Access Compliance Report Public Rights-of-Way (Curb Ramps)

Main Street: SANDHURST_PL Cross Street: DODGE_AVE Location: NE

ADA ID: RPAT211019131018 Ramp Type: Type 1 - Perpendicular Diagonal Initial Pass/Fail: Pass Overall Compliance: No Severity Score: 4

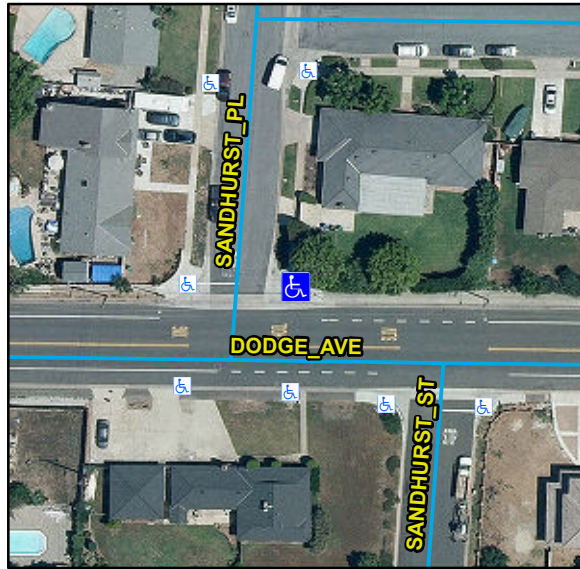
R304.2.2, R304.2.1, STD 1115

Remove & Replace Curb Ramp With Two New Directional Ramps or Equivalent.
